LEXINGTON-FAYETTE URBAN COUNTY GOVERNMENT CONTRACT CHANGE ORDER Page 1 of 11		Date:	October 1, 2025
To (Contractor):		Project:	Clays Mill Road Improvements, Section 1
L-M Asphalt Partners, Ltd.		Location:	CMR - Waco to Harrodsburg
dba ATS Construction		Contract No.	17-2020
3009 Atkinson Ave, Suite 400, Lexington, KY 40509		Original Contract Amt.	\$10,683,653.39
		Cumulative Amount of Previous Change Orders	\$1,373,272.58
		Percent Change - Previous Change Orders	12.85%
		Total Contract Amount Prior to this Change Order	\$12,056,925.97
		Change Order No.	5 - Final
You are hereby requested to comply with the following changes from the contract plans and specification;			
Current Change Order

LEXINGTON-FAYETTE URBAN COUNTY GOVERNMENT CHANGE ORDER				DATE:		October 1, 2025
				Change Order #:		5 - Final
				CONTRACT #:		17-2020
Project: Clays Mill Road Improvements, Section 1						
You are hereby requested to comply with the following changes from the contract plans and specifications;

**Clays Mill Road Improvements, Section 1
Change Order No.5 - Final
Reasons for Porposed Changes**

Clays Mill Road Waco to Pasadena Northbound Closure

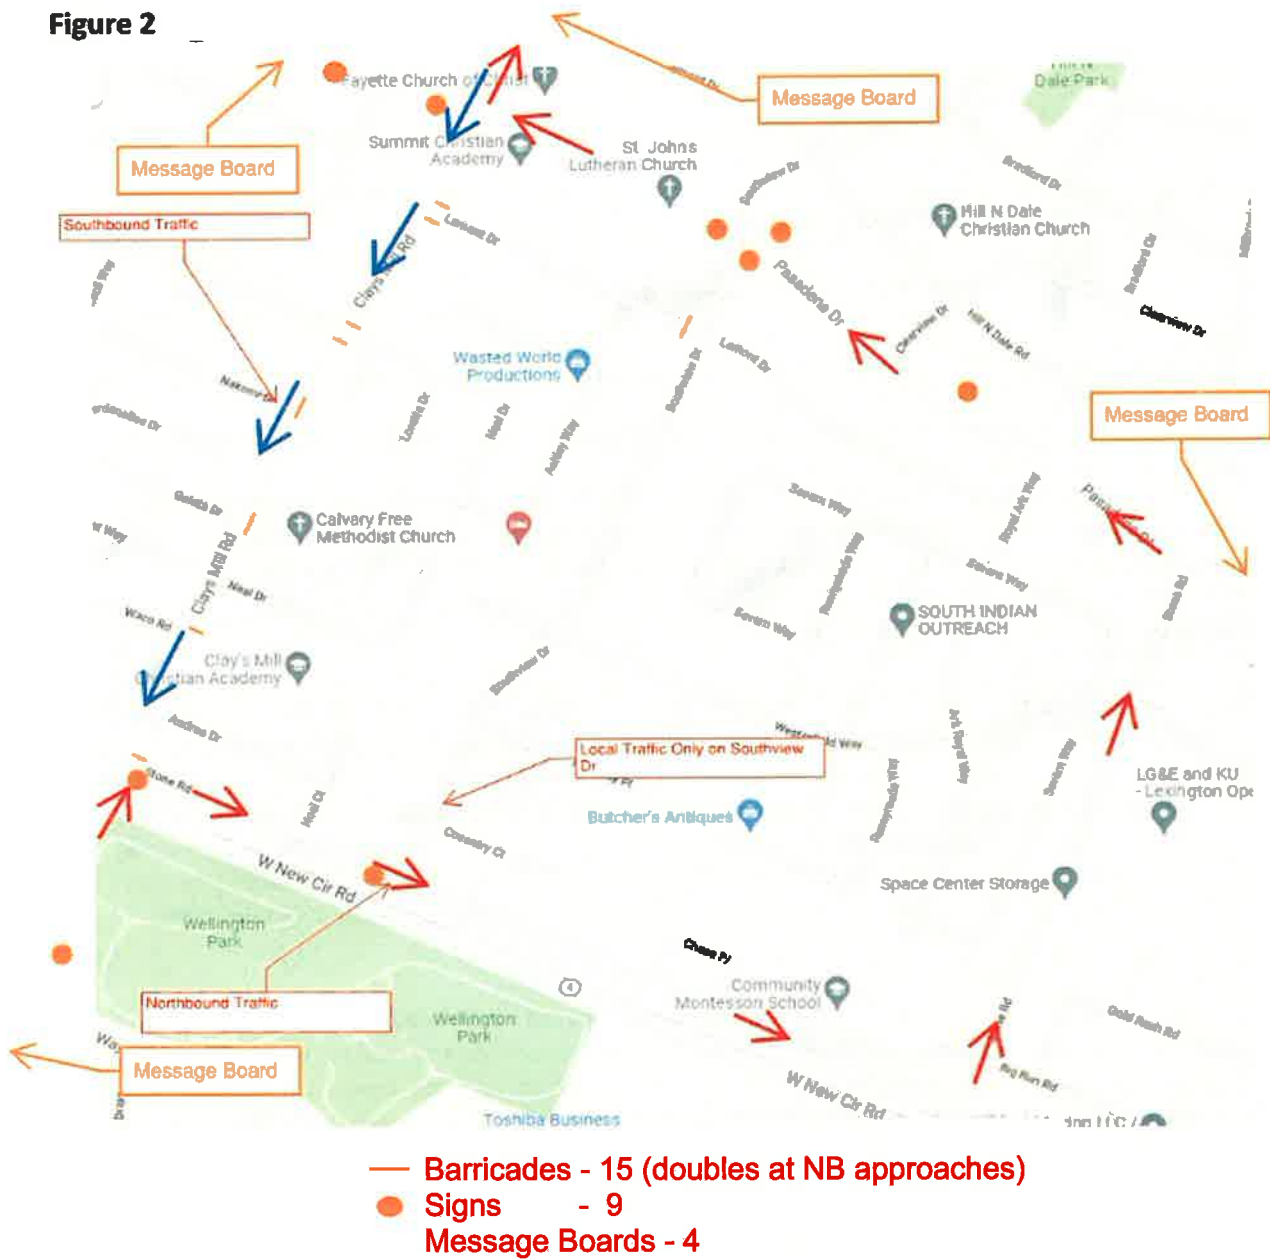
The purpose of this letter is to revise the supplemental proposal submitted on 6/24/2023 based on the attached signage plan. The quantities below reflect the amount of additional MOT used to detour Northbound traffic around Clays Mill Road from Waco Dr to Pasadena Dr.

Figure 1

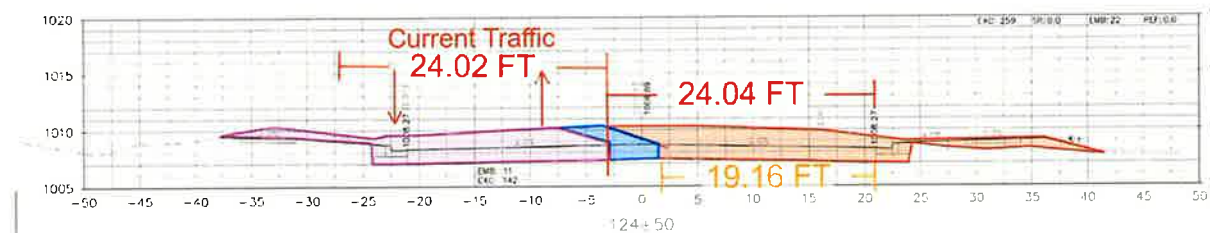
As discussed in previous conversations, it appears that the plans did not consider the elevation differences and other constraints that hinder the three-phase traffic plan. Some of these constraints, such as utility pole locations, could not be reasonably foreseen by the designer or the contractor until construction commenced. As it currently stands, the contractor cannot construct this corridor and maintain the required width for the traffic. As a worst-case scenario example, the cross section below (Figure 1) is from STA 124+50. As listed, traffic is currently on existing asphalt and temporary widening with approx. 24 ft of width. To match that width and allow for a 1 ft safety buffer on each side, 24 ft width (from edge of gutter) was used for phase 2 construction analysis. As you can see, to construct 24' width right of centerline, we would actually need to excavate right up to the existing edge of the northbound travel lane (approx. 5 ft LT of CL). While this may be physically possible, we would have a 3 ft dropoff just outside the northbound travel lane and no room for a barrier wall. Further expansion on the diversion is also not possible in this

area as there is a utility pole that already had guardrail put up around it to protect cars from hitting it. Therefore, some sort of safety wedge would have to be put in between the construction and the traffic. Due to the length of the project and some of the depths, a daily safety wedge would not be possible. Because of the items listed above and the need for a safety wedge, construction would have to impede on the Northbound traffic to build enough width to move traffic onto the newly constructed pavement.

1. Keep Traffic as is and Excavate red area (Figure 1).
2. Build Curb, DGA, 2 layers of asphalt base approx. 19' wide and sidewalk
3. Once Sidewalk is completed, close the Northbound lane of Clays Mill Road and put traffic on detour in Figure 2
4. Excavate and construct Blue area (Figure 1) through second asphalt base layer
5. Simultaneously, backfill Curb and Sidewalk and all remaining finish work behind curb.
6. Pave final Asphalt Base Layer, place Temporary Striping, and switch traffic.

1892 CMR
Image 1 of 2

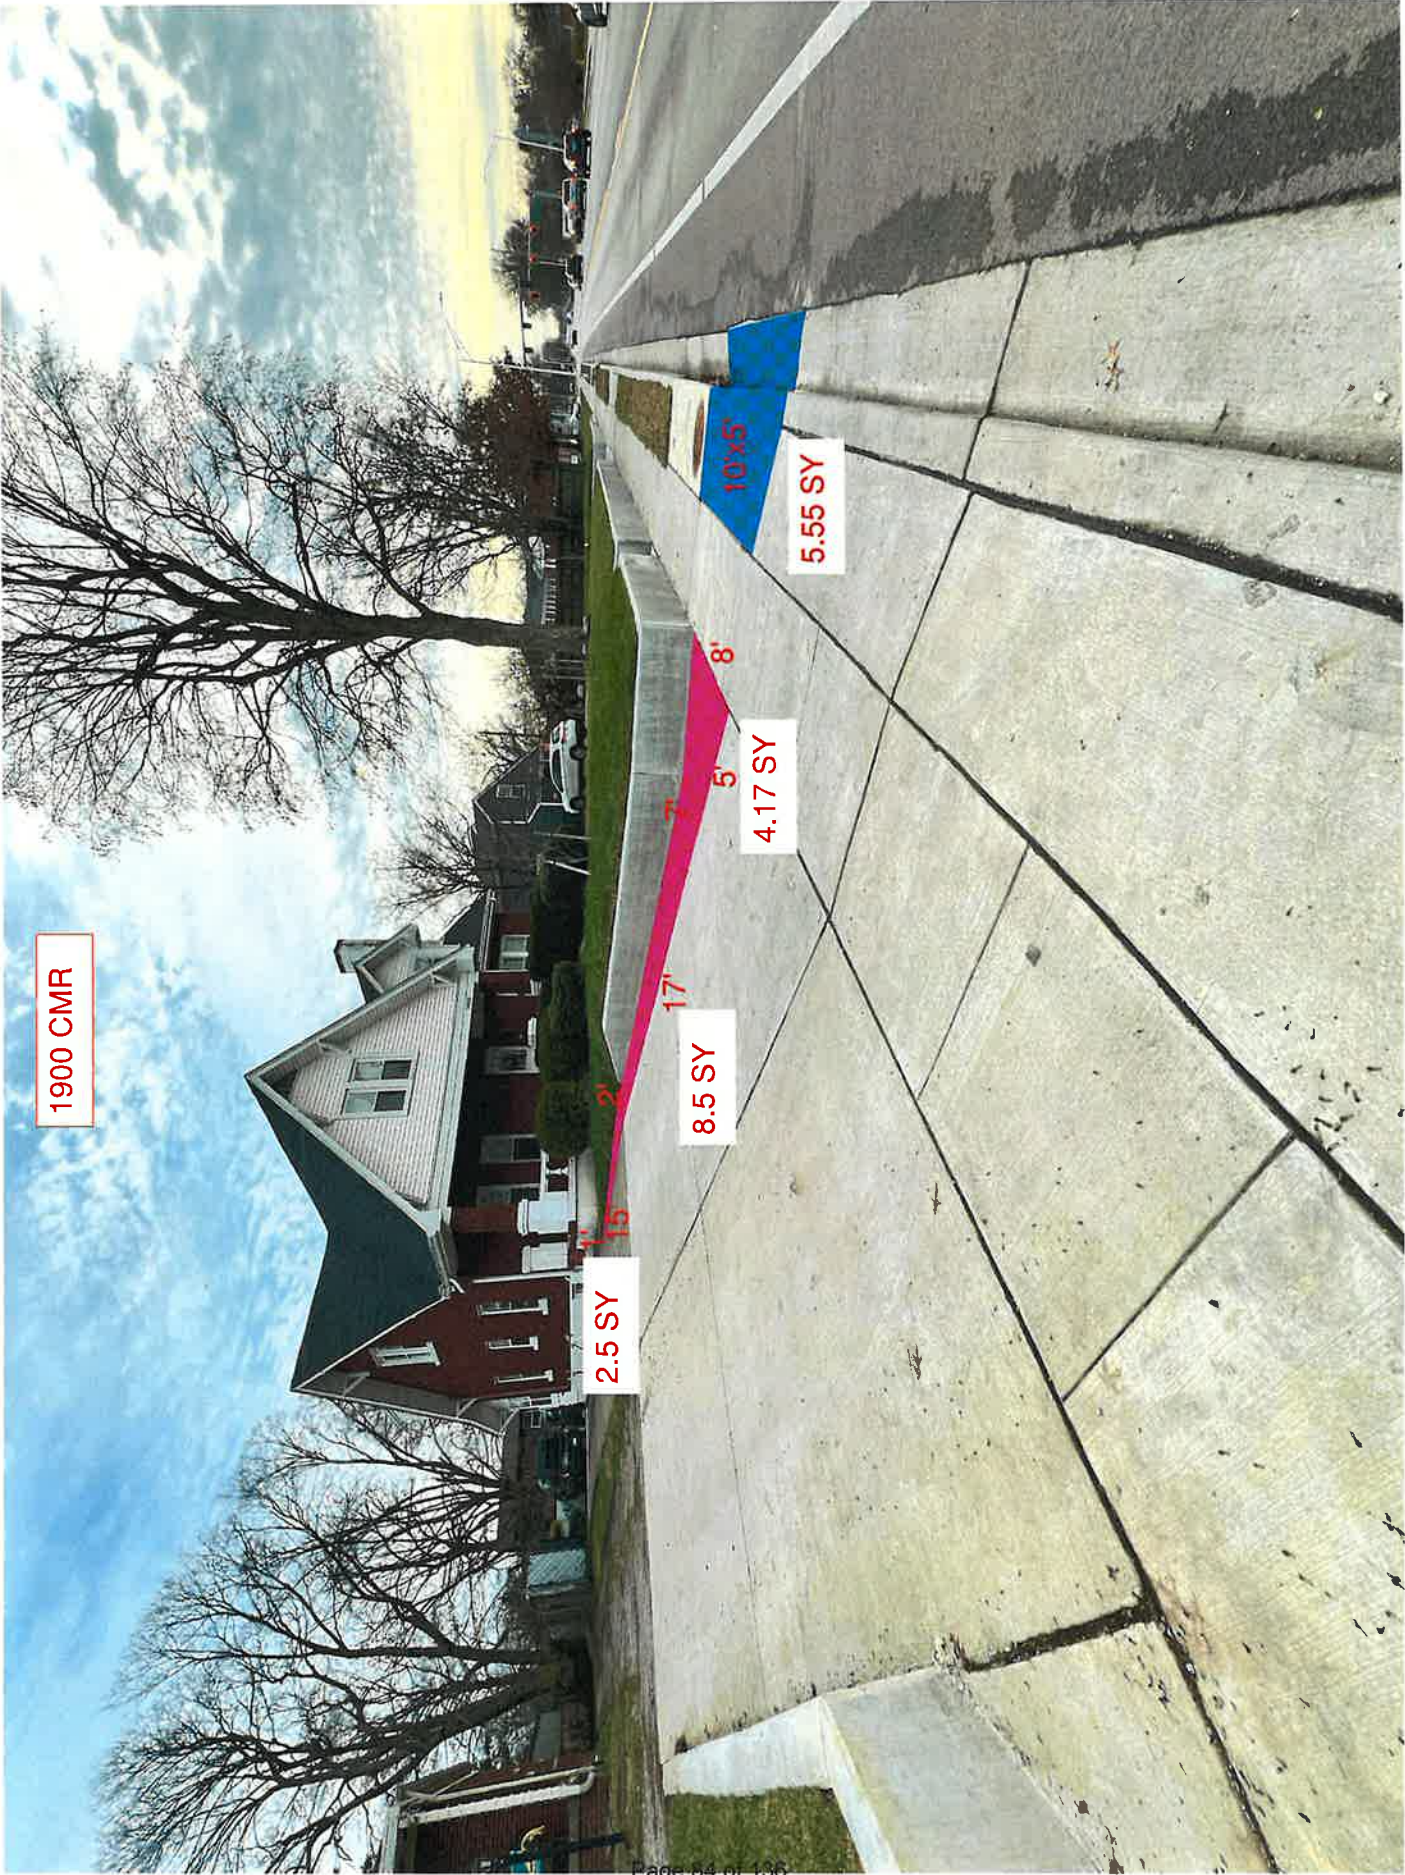
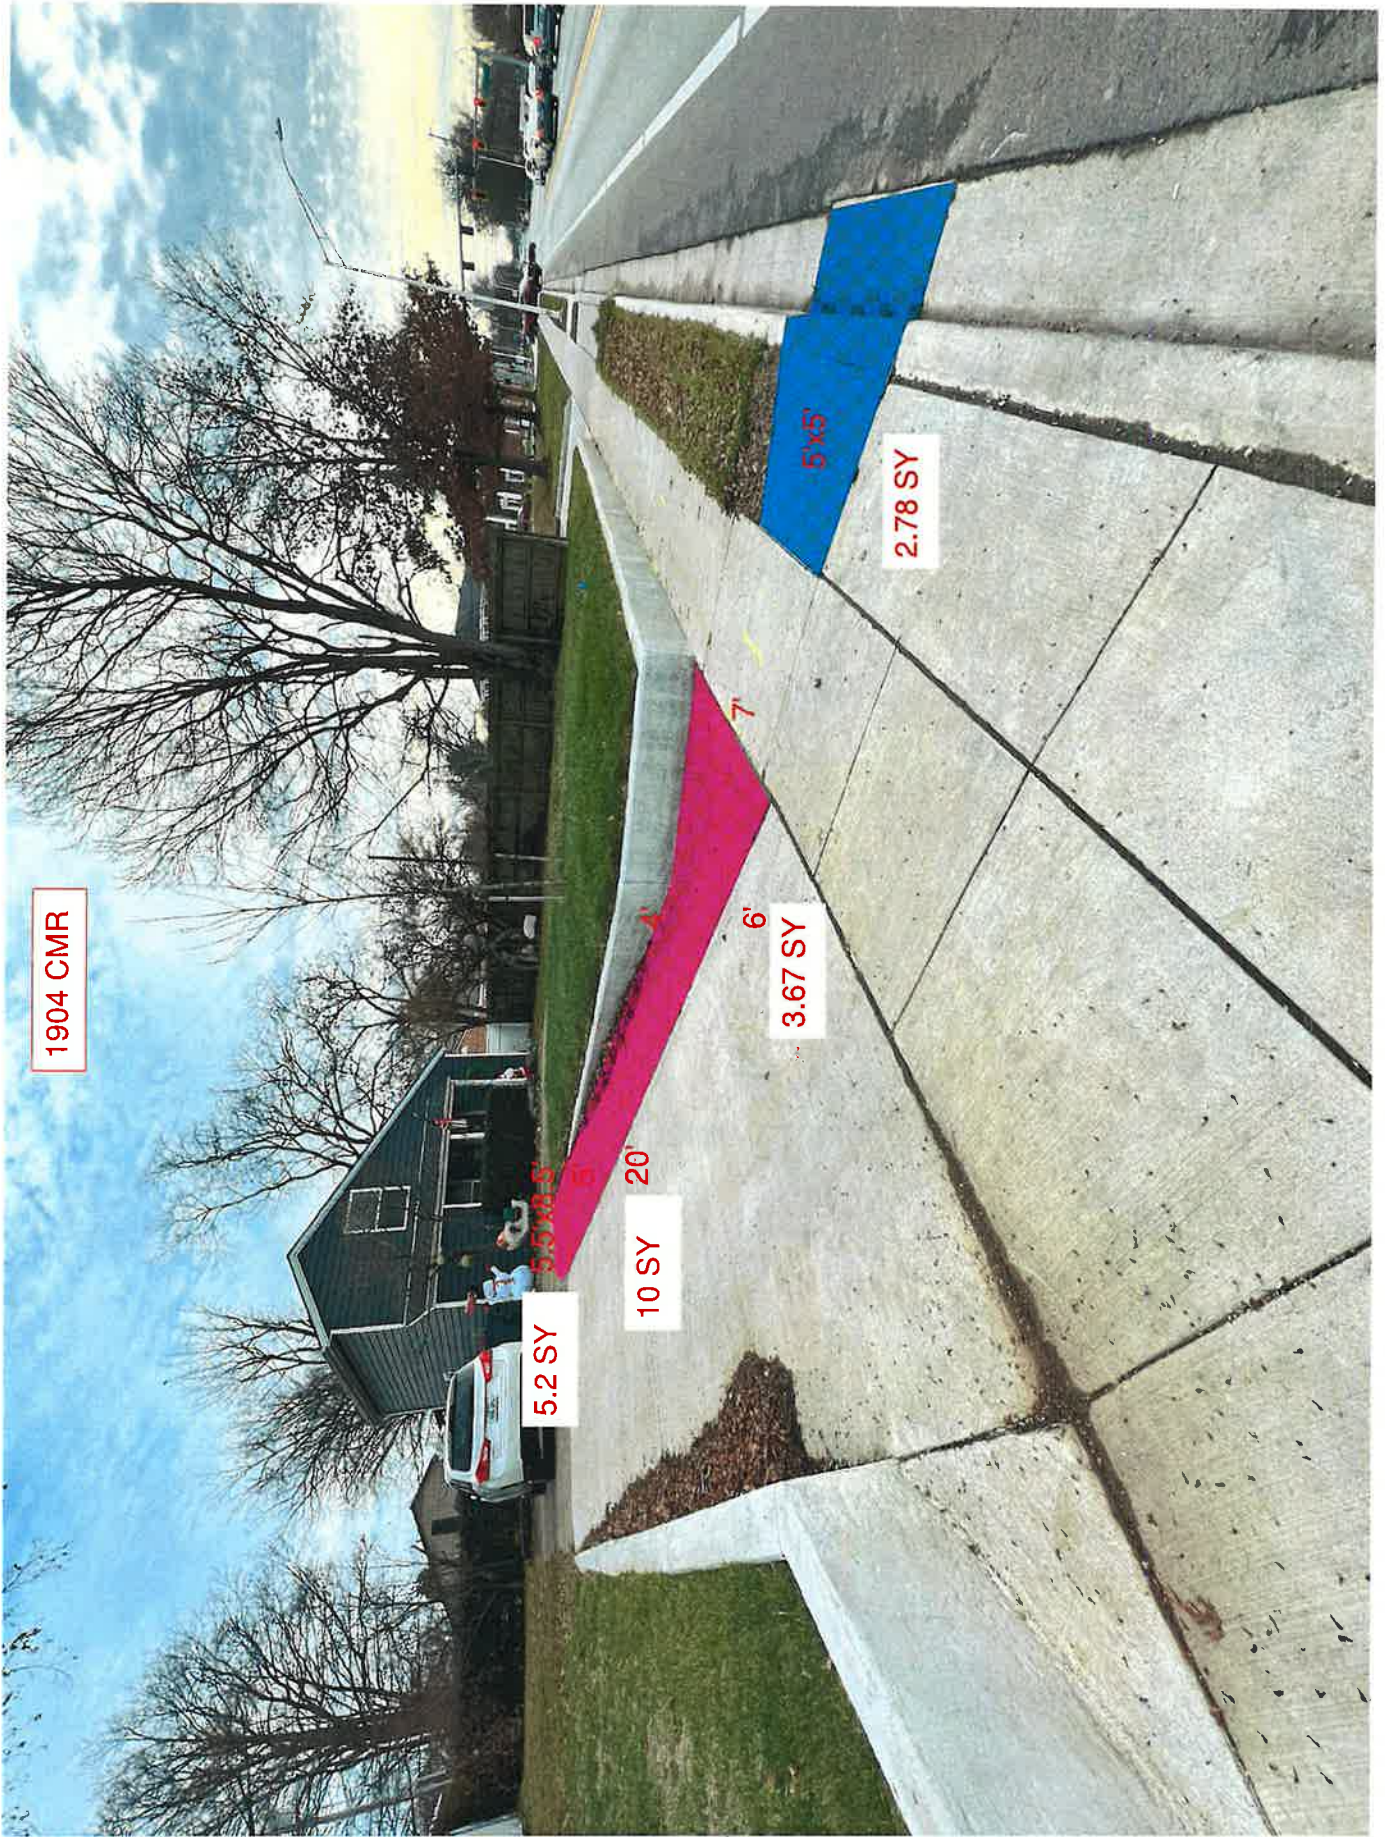
In conjunction with the retaining wall revisions change order proposal (ref # 10099), ATS Construction submits the following pricing for additional driveway pavement completed because of the retaining wall revisions. The pricing is broke out between new entrance pavement and entrance pavement that was removed and replaced. Photos and area breakouts are attached to this letter (Pink=New Pavement, Blue=Remove & Replace). Both options have previously agreed upon pricing.

Address	Type	Area (SY)	UP	Amount	Notes
1892 CMR	New	27.50	\$ 65.00	\$1,787.50	3 Areas Combined
1892 CMR	Replace	5.00	\$ 325.00	\$1,625.00	
1894 & 1896 CMR	New	12.41	\$ 65.00	\$ 806.65	2 Areas Combined
1900 CMR	New	15.17	\$ 65.00	\$ 986.05	3 Areas Combined
1900 CMR	Replace	5.55	\$ 325.00	\$1,803.75	
1904 CMR	New	18.87	\$ 65.00	\$1,226.55	3 Areas Combined
1904 CMR	Replace	2.78	\$ 325.00	\$ 903.50	
				\$9,139.00
